# Evolution of the Elefant chip from prototype version to production version.

## Henrik von der Lippe

Lawrence Berkeley National Lab.

October 7th 1997

# TDC

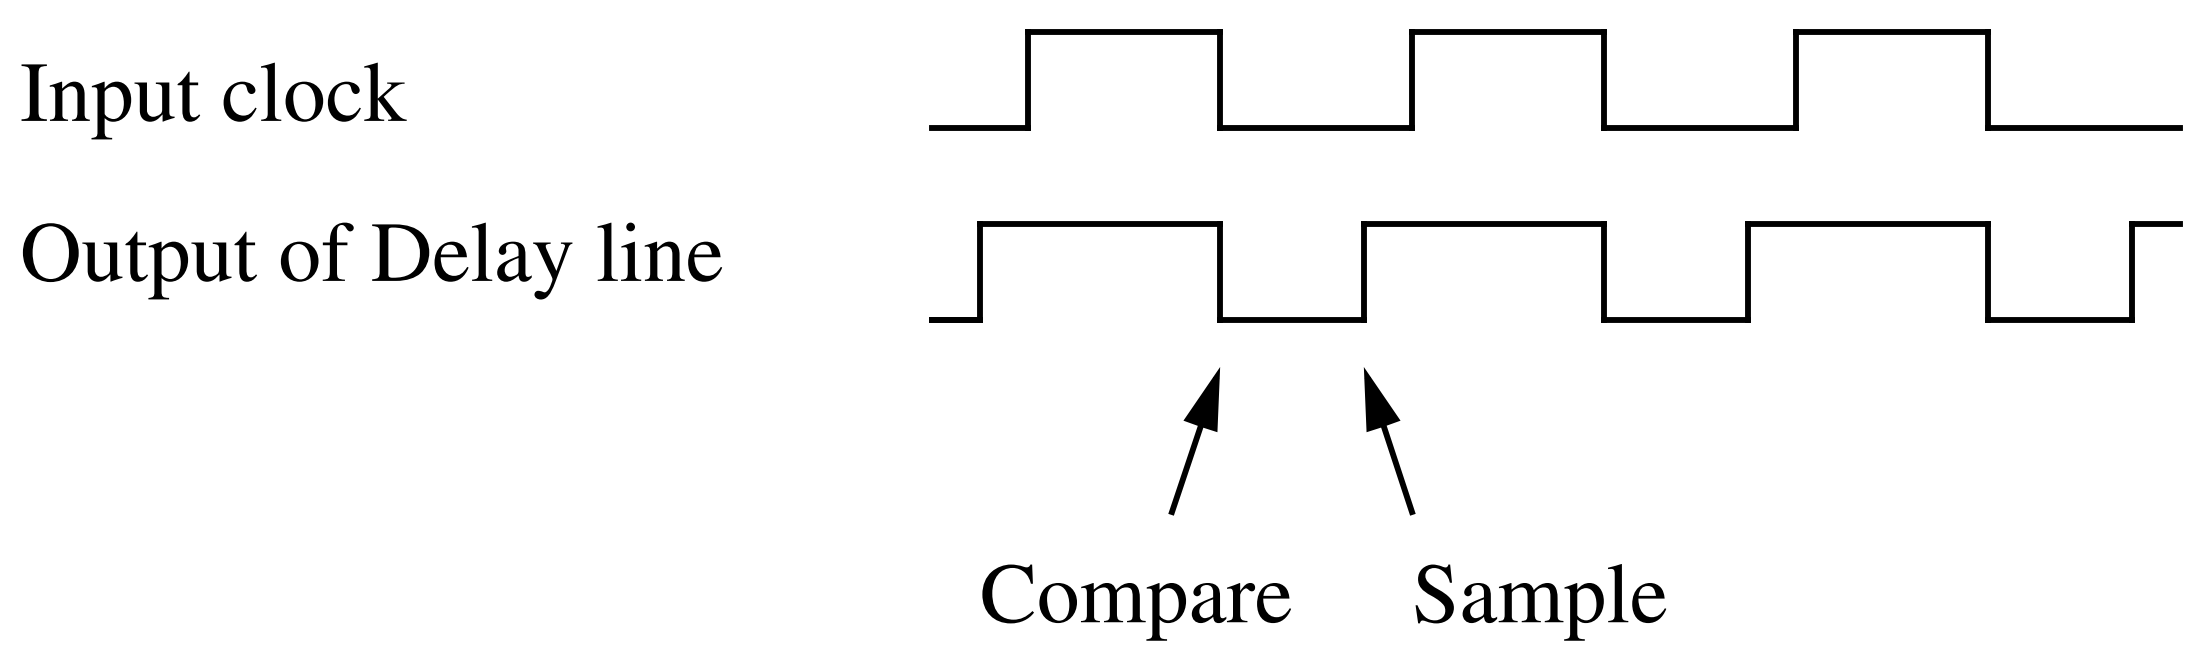
Problem: Missing Code 0.

Error: Phase detector sensed falling edge of clock signal while rising edge was used to sample data. Leading edge versus falling edge dispersion ~ 1ns.

Fix: The input to the phase detector were inverted.

## Analog Receiver

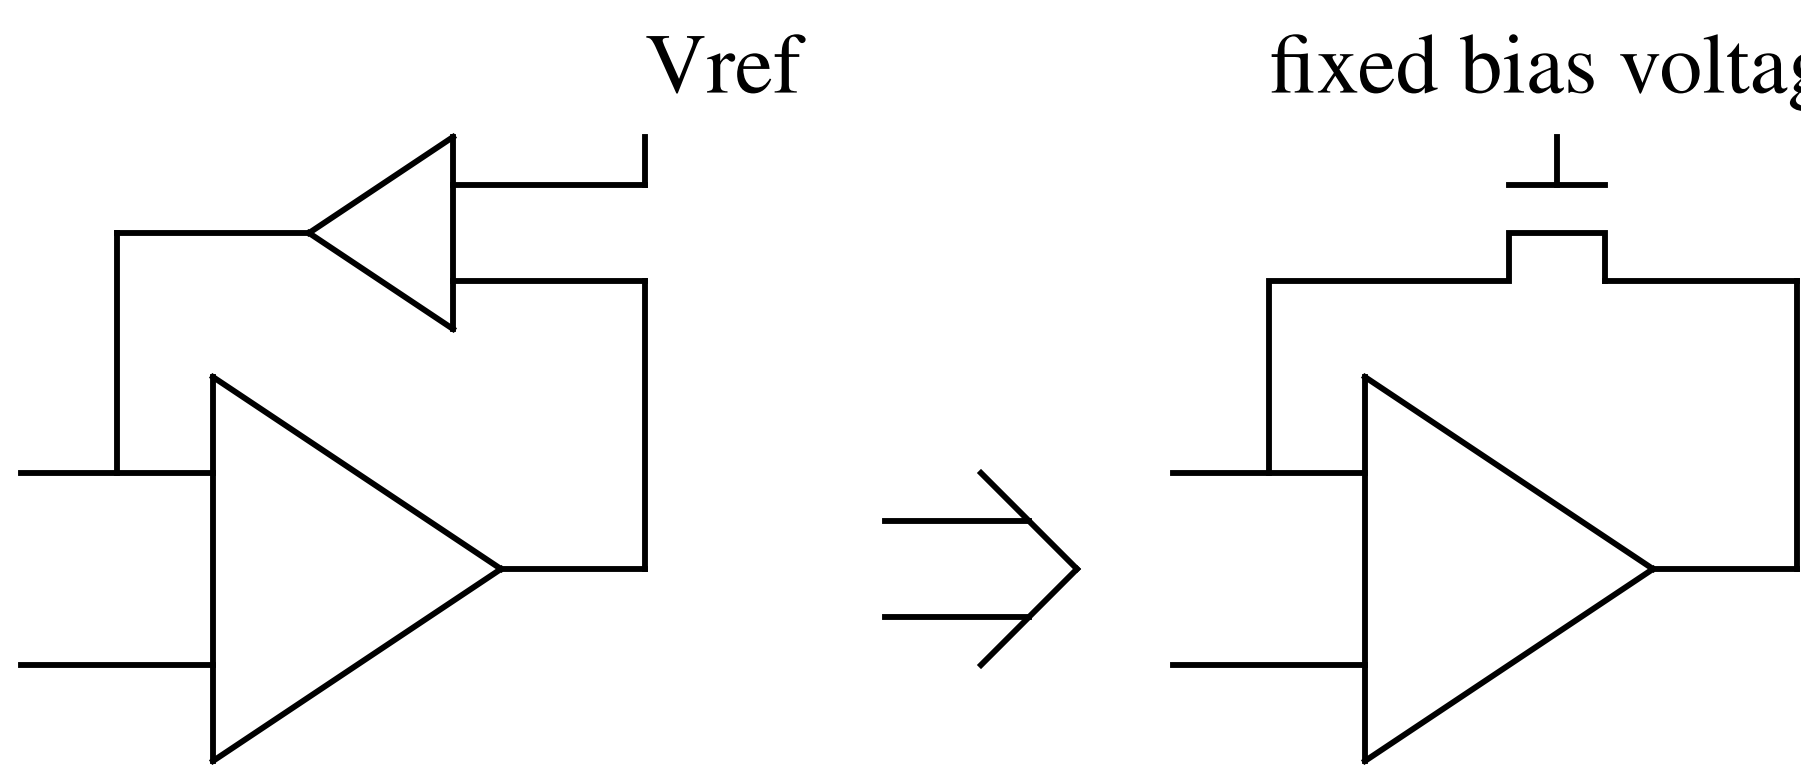
Problem: Analog receiver had poor yield (15%).

Error: Incorrect bias of the reset amplifier, due to sensitivity to process variations.

Fix: Active reset amplifier substituted with a NMOS as feedback resistor.

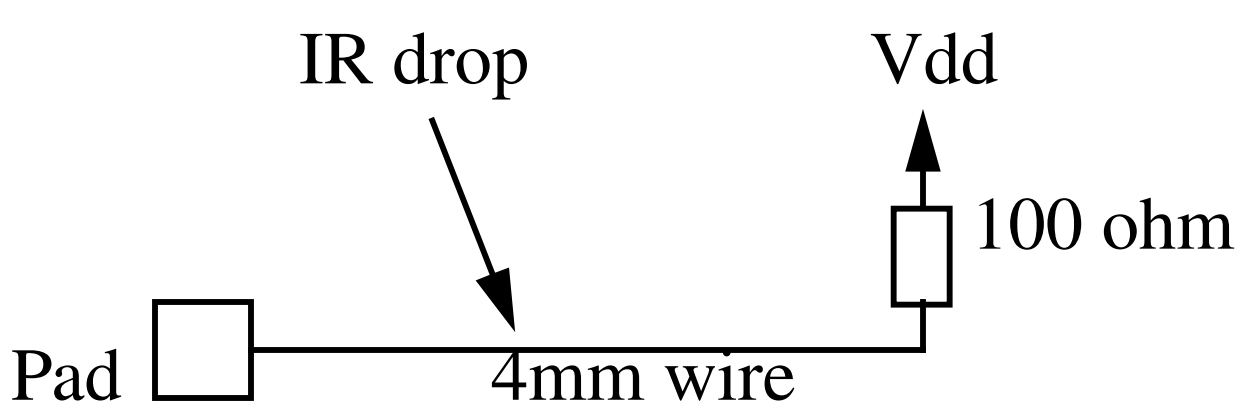
Problem 4: Location of digital input pullups.

Fix: Resistor moved to pad.

## Analog receiver

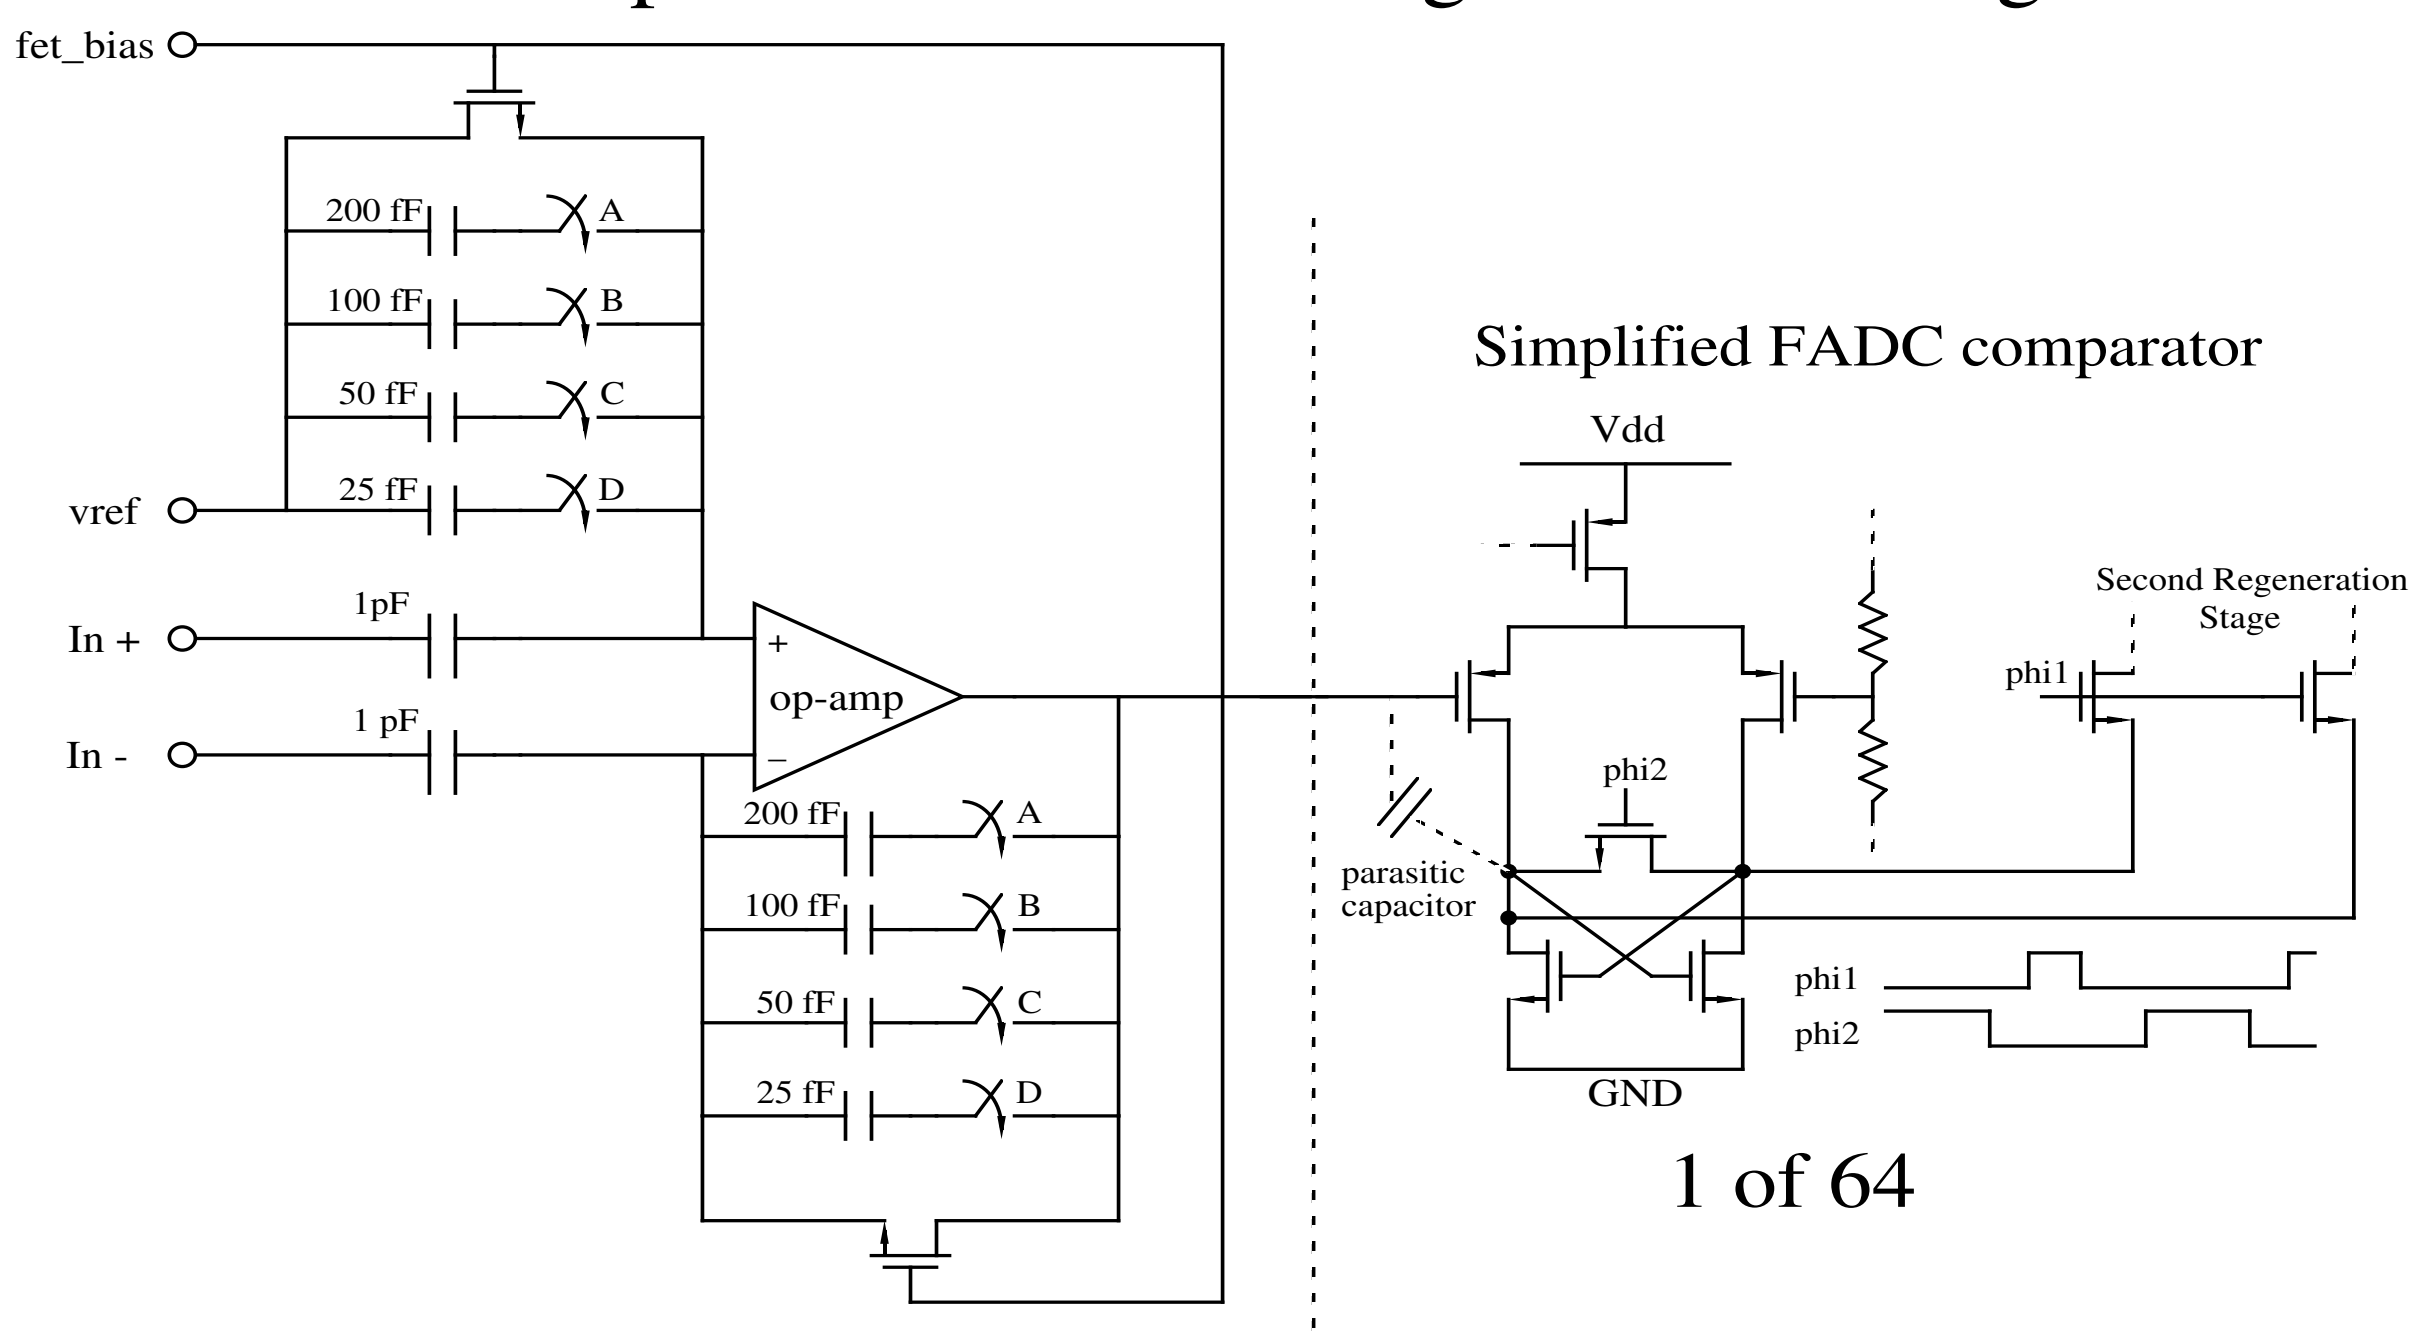
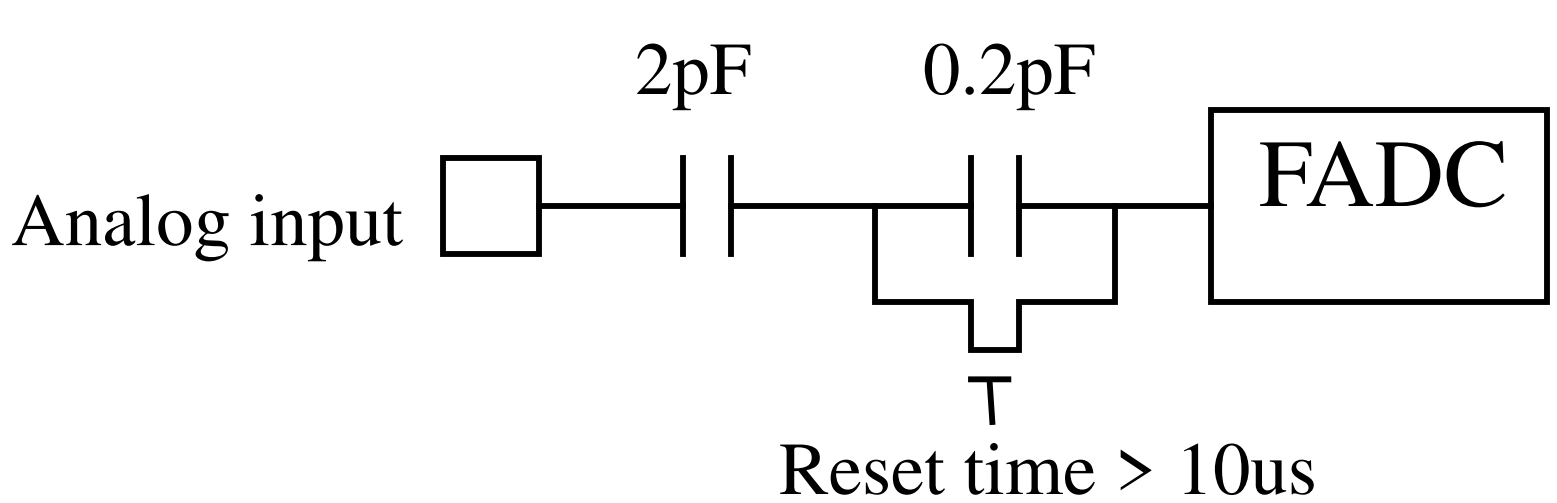
Problem: 0.5 V offset.

Error: Kickback from the FADC comparator. Output impedance of the analog receiver to high.

# Kickback on digital input lines.

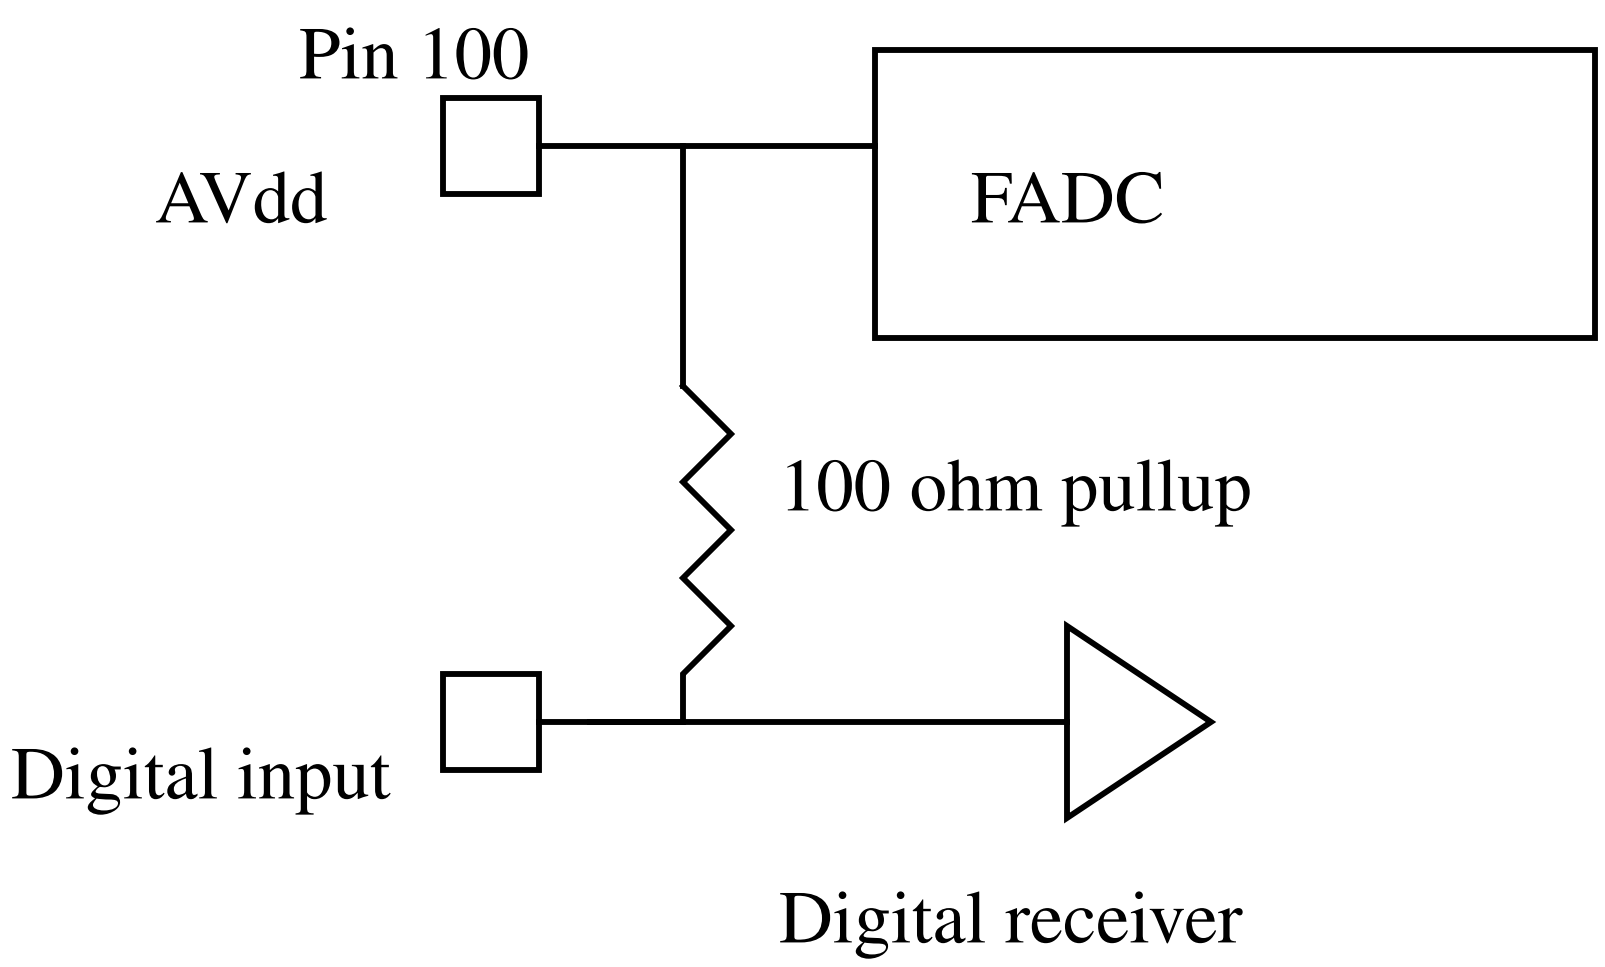
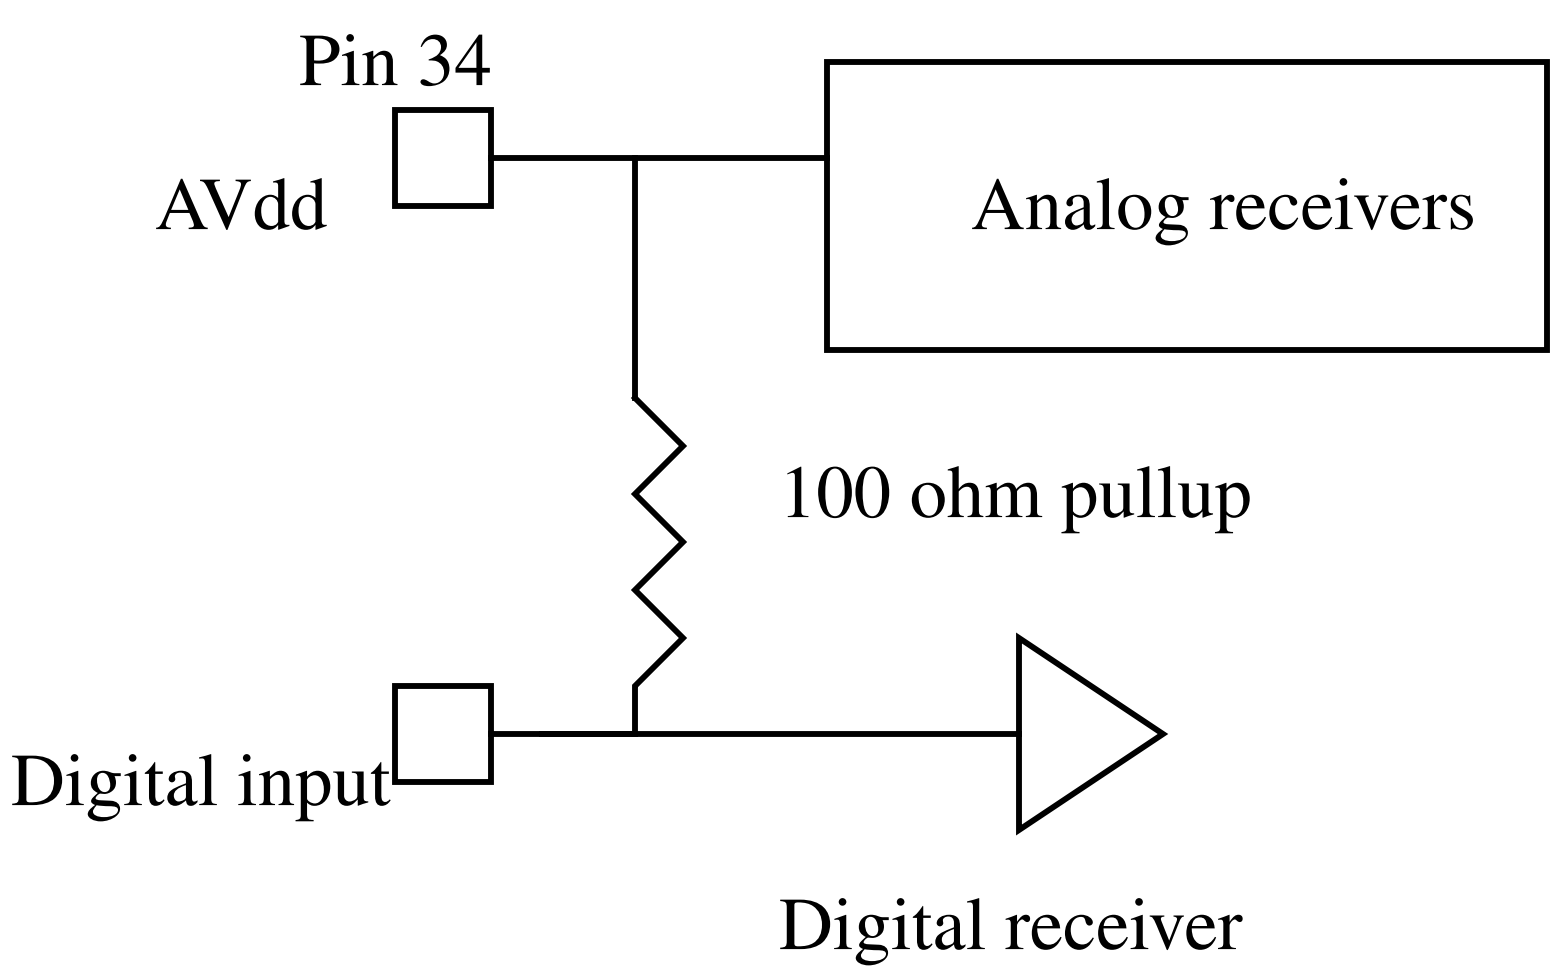
Problem: Analog VDD supporting the FADC and the 100 pullup resistors is noisy.

Fix:
